PRODUCT CONTROL NOTICE OF ACCEPTANCE

Your application for Notice of Acceptance (NOA) of:
"Dura Rib" 0.026" (min.) Structural Galvalume Steel Roof Panel System
under Chapter 8 of the Code of Miami-Dade County governing the use of Alternate Materials and Types of Construction, and completely described herein, has been recommended for acceptance by the Miami-Dade County Building Code Compliance Office (BCCO) under the conditions specified herein.

ACCEPTANCE NO.: 01-0718.10
EXPIRES: 08/27/2006

SUBMITTED BY: KWON S. KIM	FL. PE#: 30320
DWG. NO. 98D SHEET 1 OF 3	DATE : 1-15-98

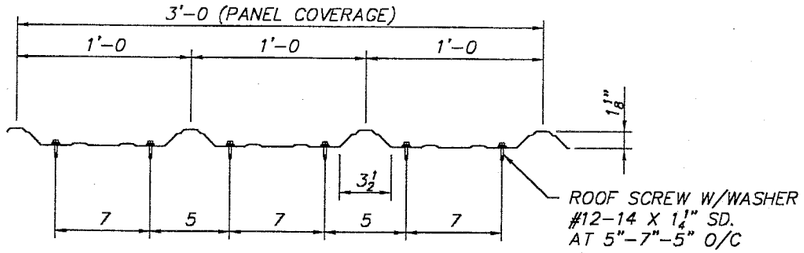
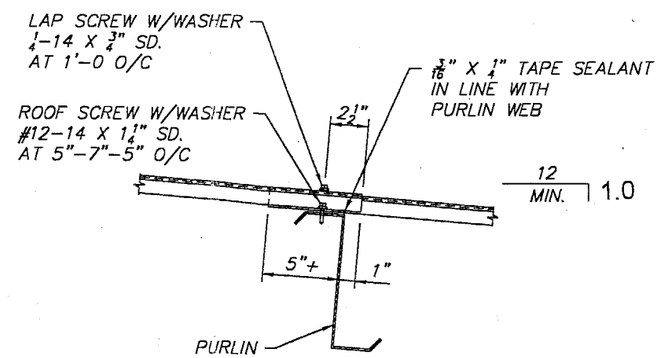
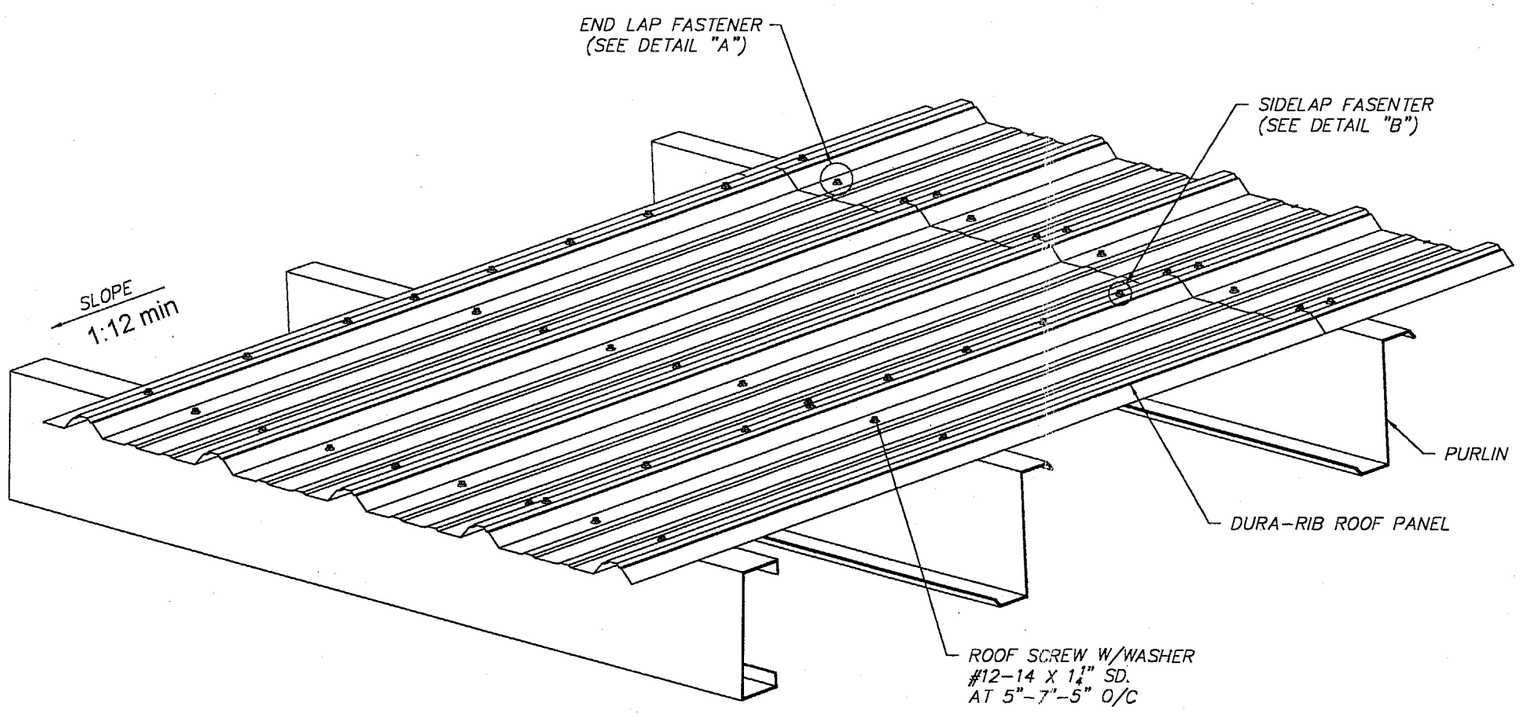
Rev. 08-02-01 per the Code
1. 24 gage to 0.026" coated thickness
2. min. roof slope from 1/2:12 to 1:12

SUBMITTED BY: KWON S. KIM	FL. PE#: 30320
DWG. NO. 98D SHEET 2 OF 3	DATE : 1-15-98

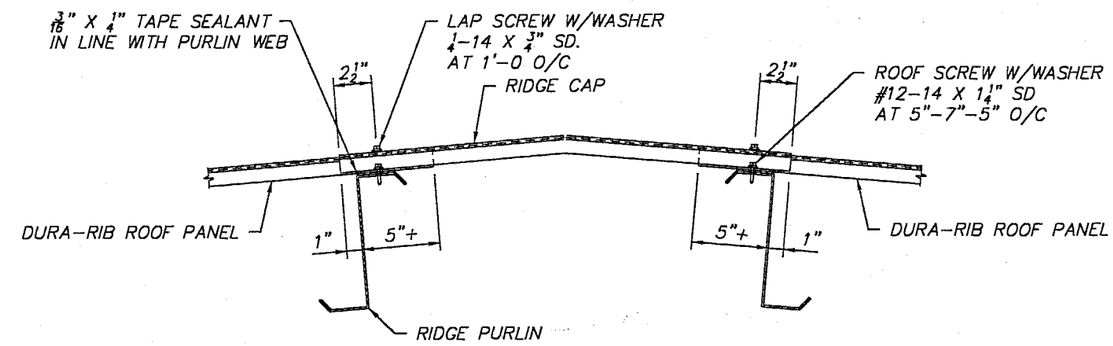
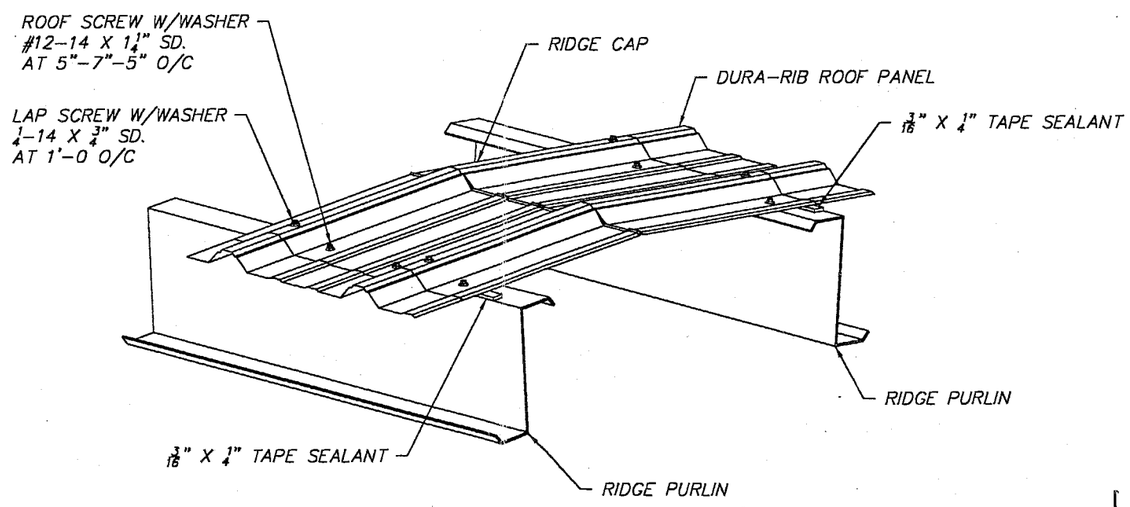
Rev. 08-02-01 per the Code
1. 24 gage to 0.026" coated thickness
2. min. roof slope from 1/2:12 to 1:12

SUBMITTED BY: KWON S. KIM	FL. PE#: 30320
DWG. NO. 98D SHEET 3 OF 3	DATE : 1-15-98

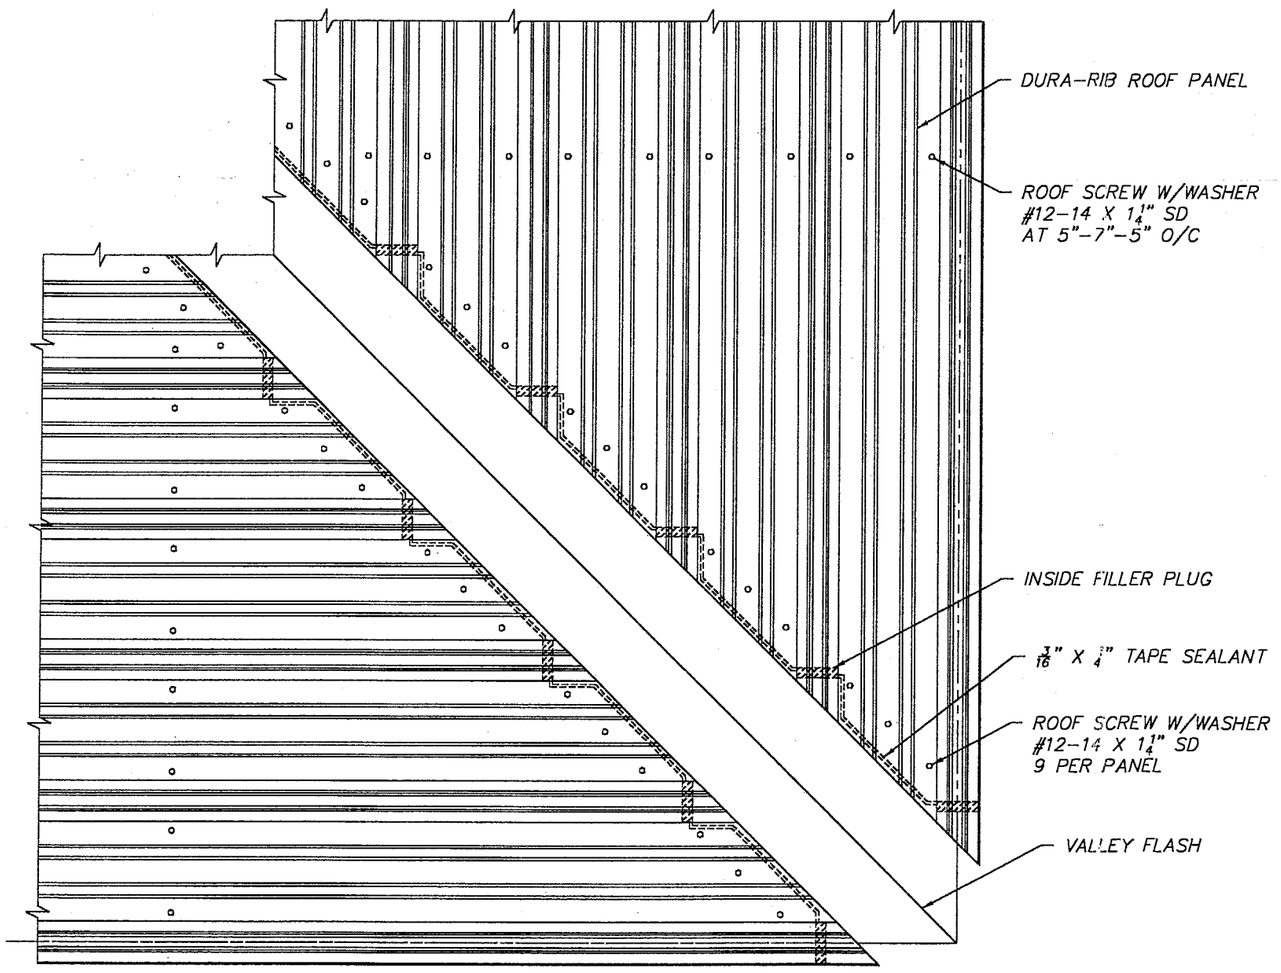
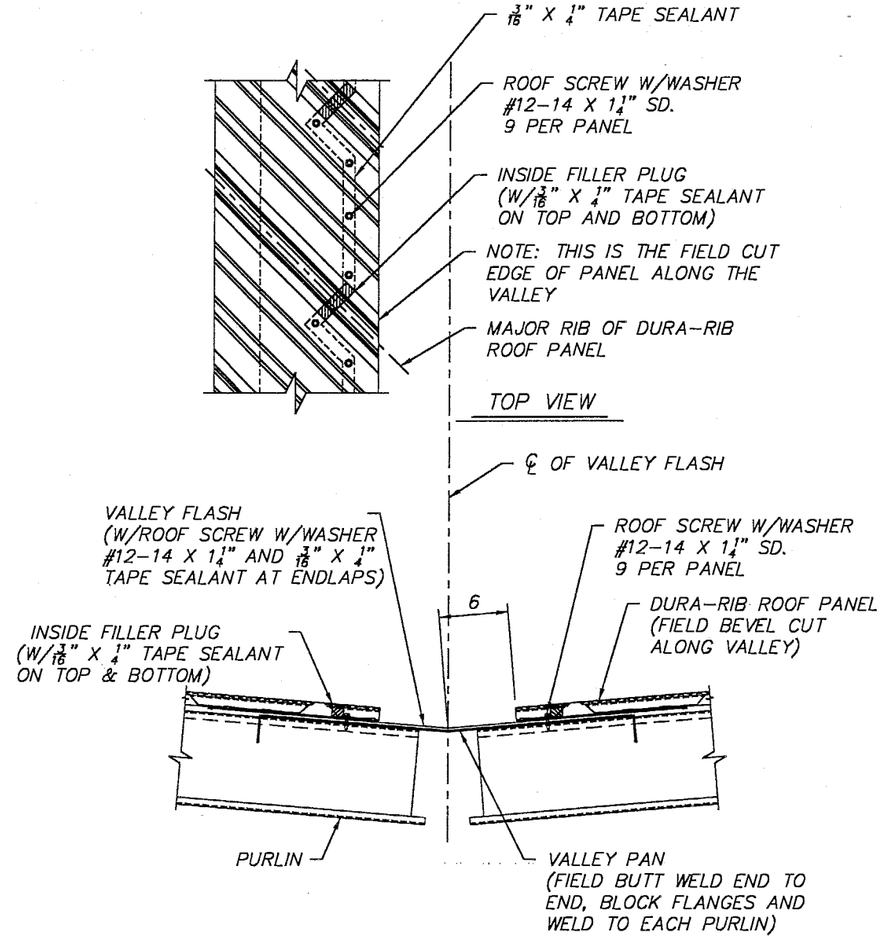
Rev. 08-02-01 per the Code
1. 24 gage to 0.026" coated thickness
2. min. roof slope from 1/2:12 to 1:12
